Docket Number:	19-SPPE-03
Project Title:	Sequoia Data Center
TN #:	233084
Document Title:	CEC Staff ROC with SVP regarding reliability of system
Description:	N/A
Filer:	Scott Galati
Organization:	DayZenLLC
Submitter Role:	Applicant Representative
Submission Date:	5/22/2020 9:26:33 AM
Docketed Date:	5/22/2020

CALIFORNIA ENERGY COMMISSION
REPORT OF CONVERSATION Page 1 of 1

PROJECT TITLE: Laurelwood Data Center **Docket:** 19-SPPE-01

SUBJECT: Siliocon Valley Power (SVP) Responses to Questions from Staff

DESIGNED BY	LAURELWOOD SUBSTATION	DRAWN BY ENG	DATE/REV/APP
APPROVED BY	SINGLE-LINE DIAGRAM	SCALE: NS	SHP #/REV
			SH 1 OF 1

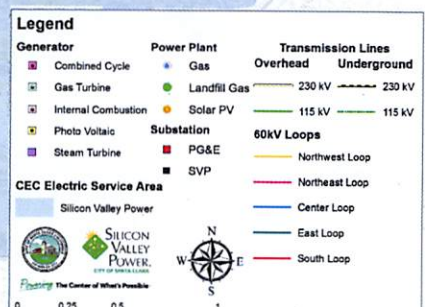
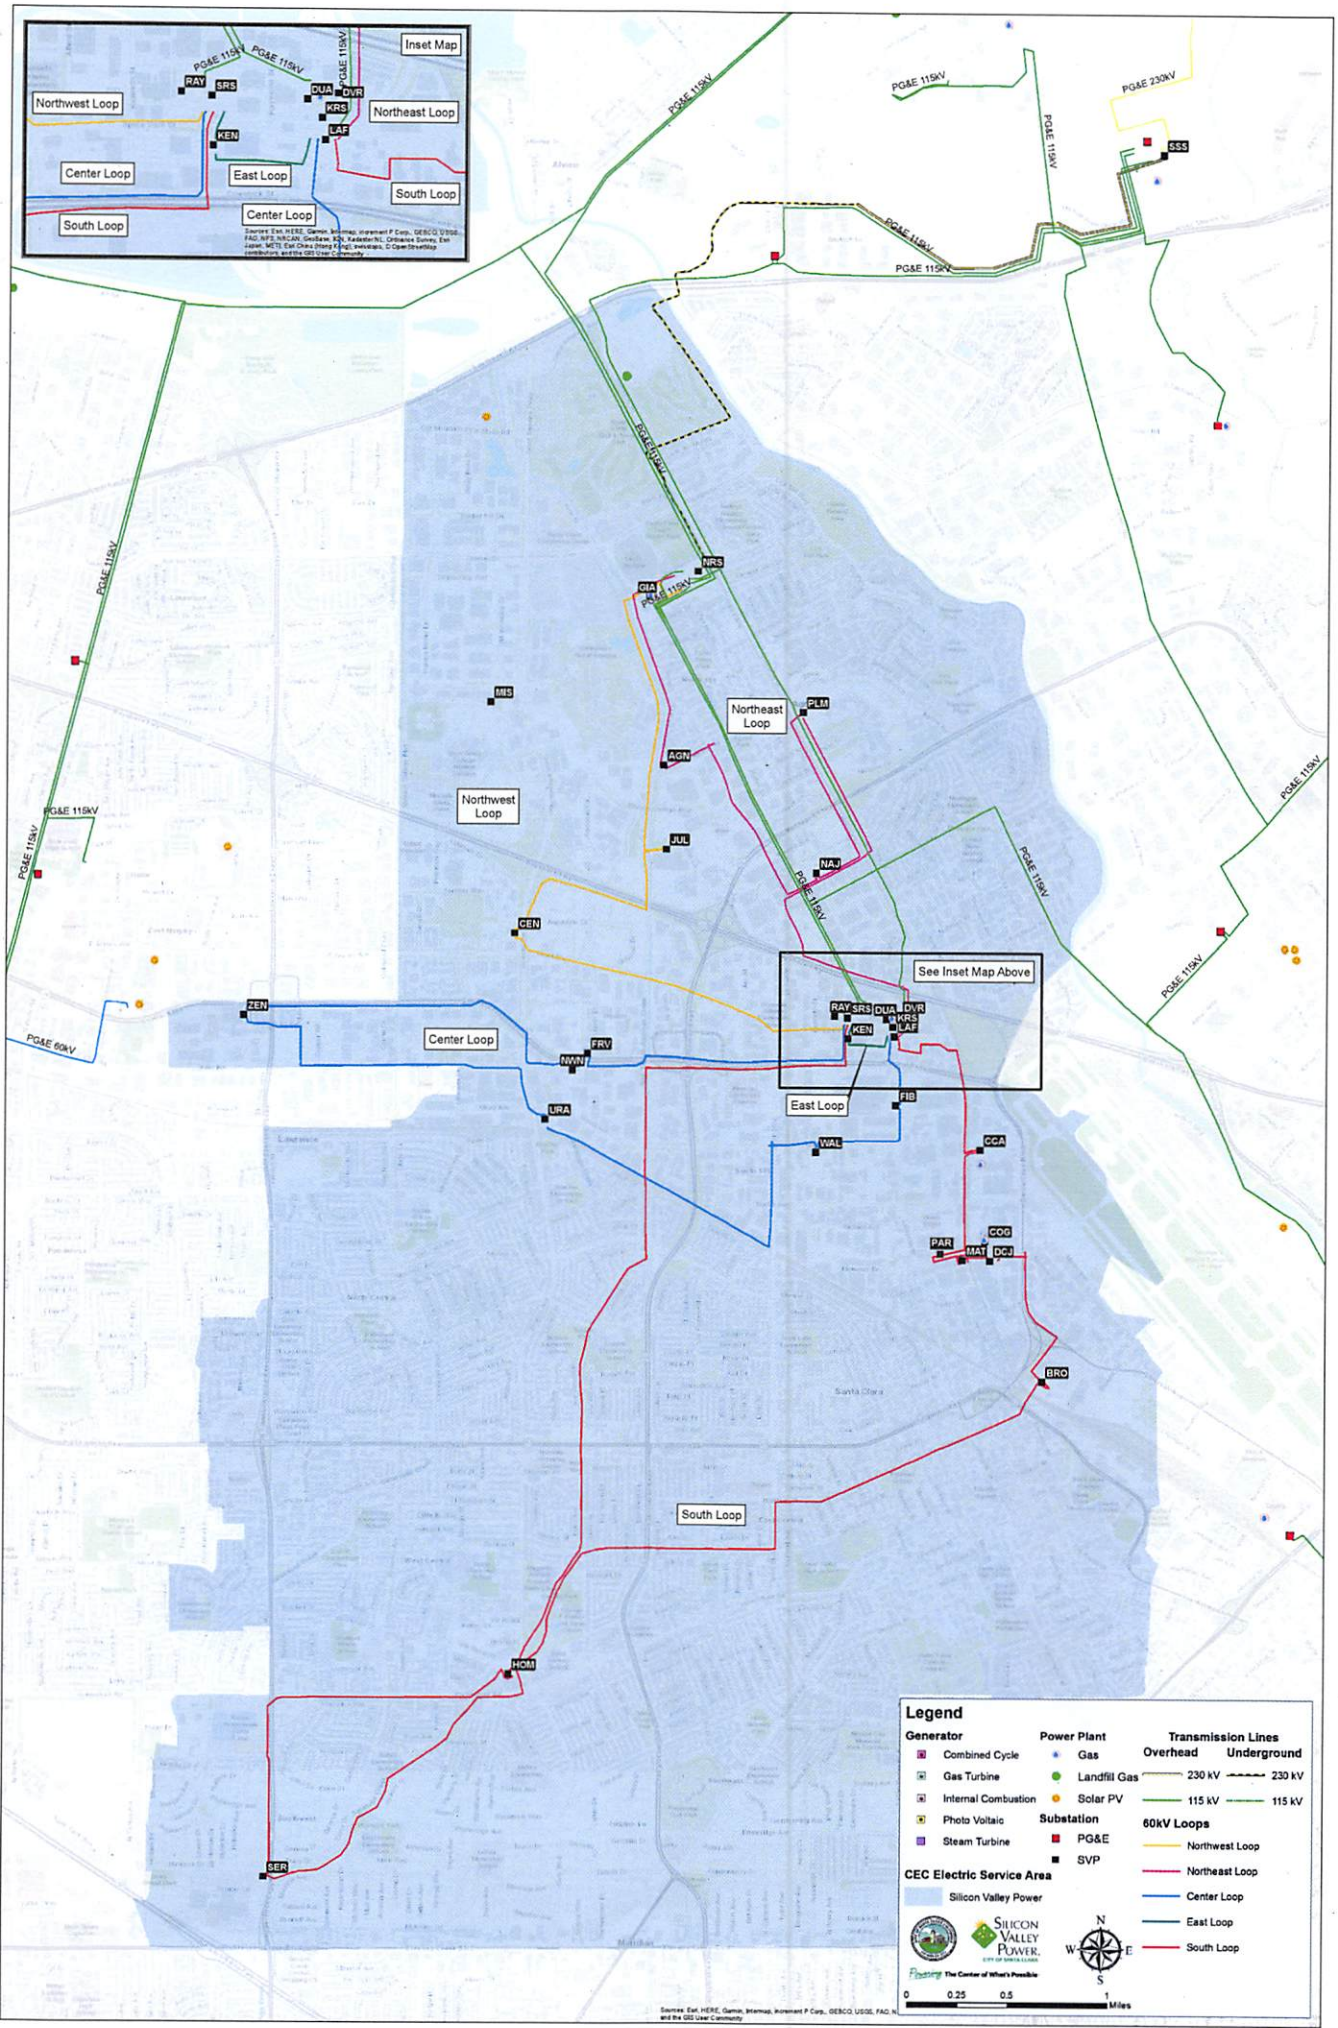
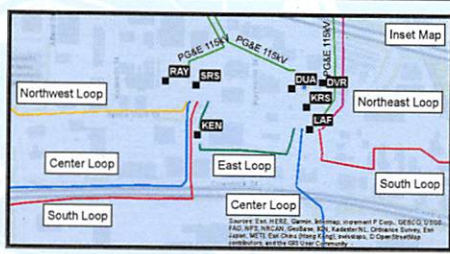
1. Please provide for the 60 kV loop on the SVP system that will serve the Laurelwood data center:

- a. A physical description

- c. The breakers and isolation devices and use protocols

Laurelwood Substation is a three-50MVA (60kV:12kV) transformer bank substation on SVP's 60kv South Loop. It is located between our 115kV Kifer Receiving Station (KRS), and 60kV substation, CCA. Each Transformer has a rating of 30/40/50 MVA, IEEE max temperature rise of 65 C, increases the capability by 10% or 33/44/56 MVA. The final buildout of Laurelwood substation will have a capability of 100 MVA, with 150 MVA of installed capacity which increases its reliability. Laurelwood Substation Single Line Diagram XXX-E-0-X-1 is attached.

There are four 60kV Breakers at Laurelwood, CB12, CB22, CB32 and CB42 which will enable various isolation schemes to insure a transformer bank can be isolated while the other two transformers remain in service. The system is designed such that one of the transformers can be taken out of service for repairs or maintenance while the other two can fully support customer load.

SVP Transmission Overview

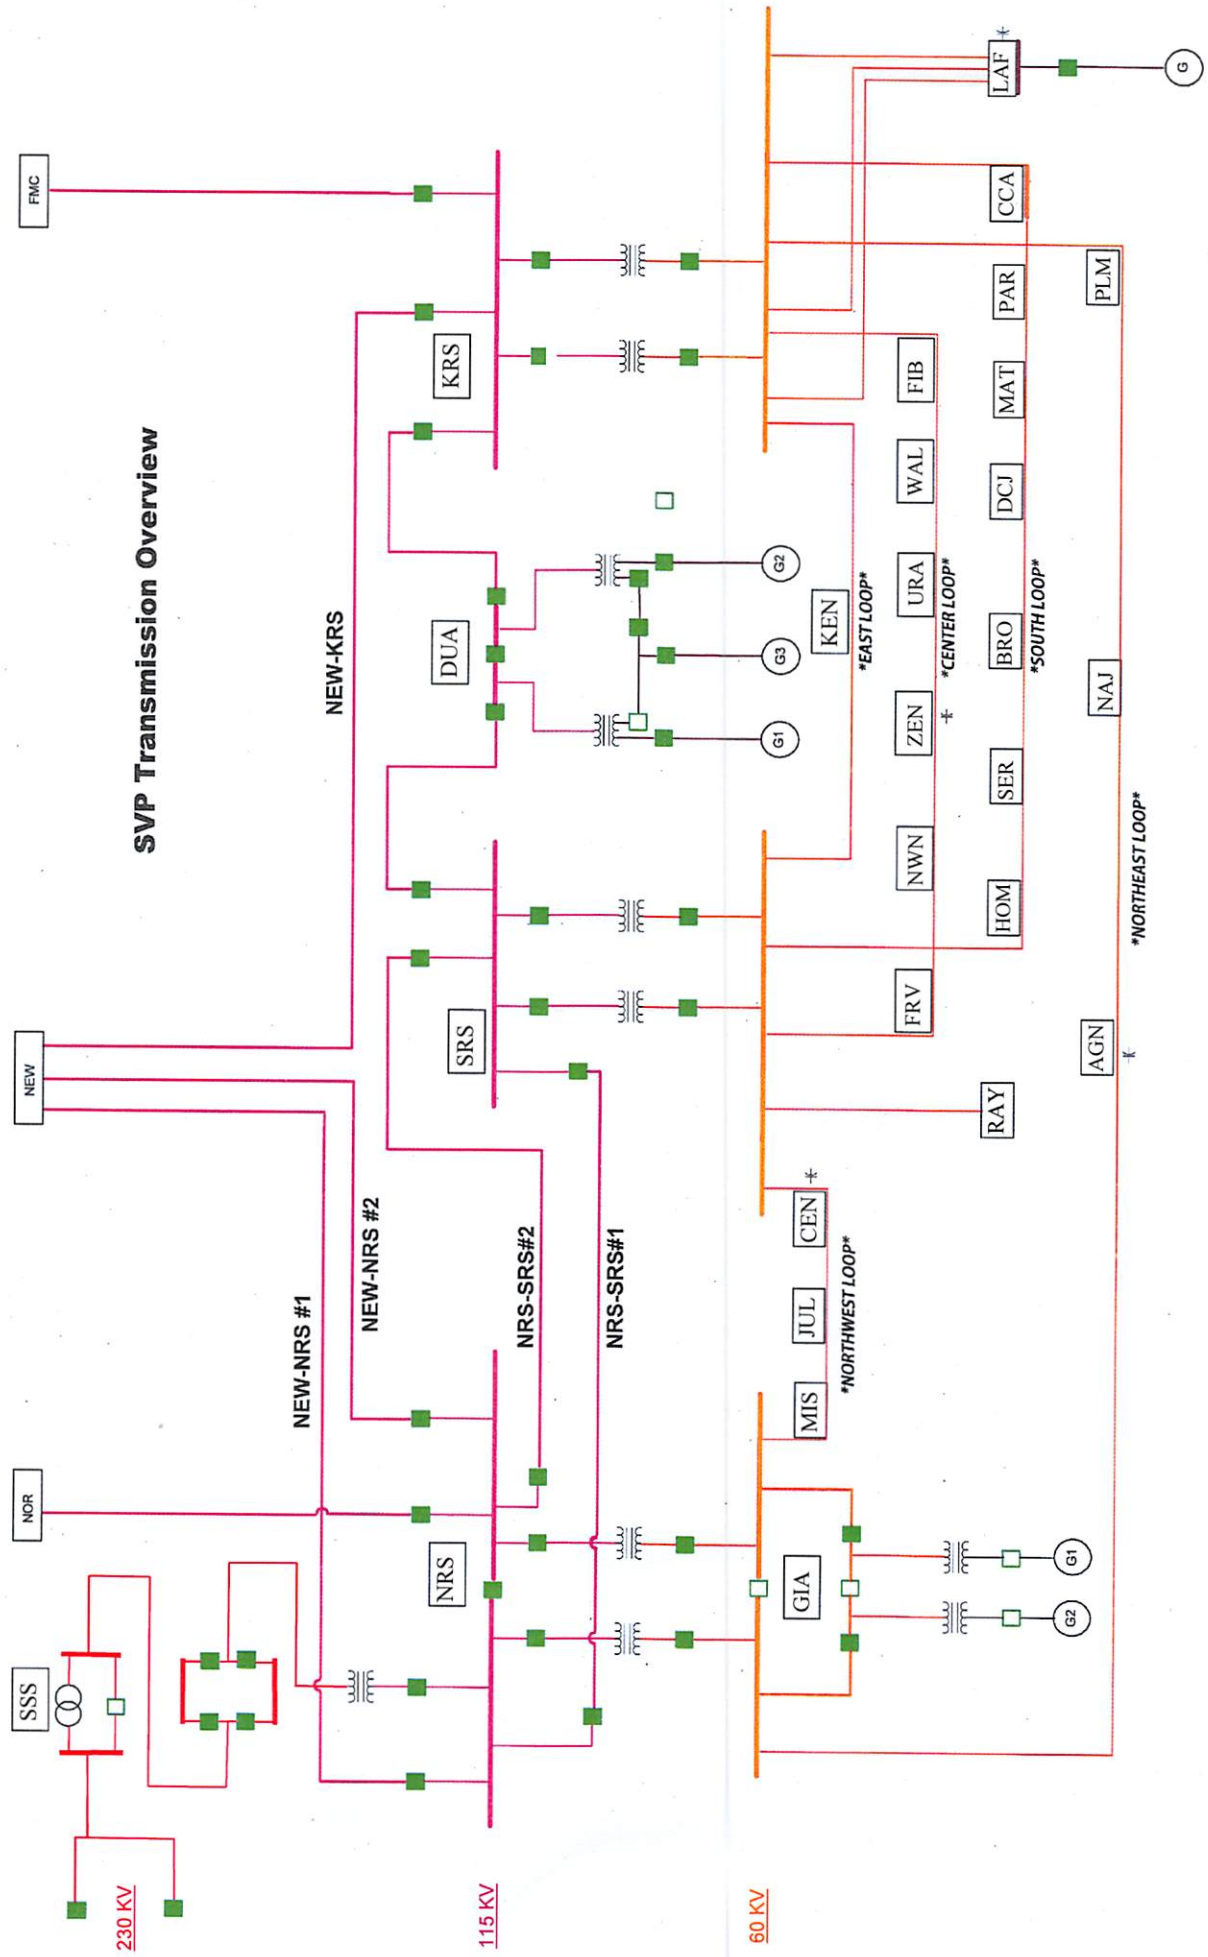
2. Please provide a description of the SVP system in general and the other 60 kV loops that would serve data centers.
 - a. Could you provide a one-line diagram and a "*.shp" file of the 60 kV and above lines serving the Silicon Valley Power System? Would you have any concerns with us using either of these in a public document?

See Attached Diagram SVP CA Energy Map 8-2-19 and the SVP Network Diagram
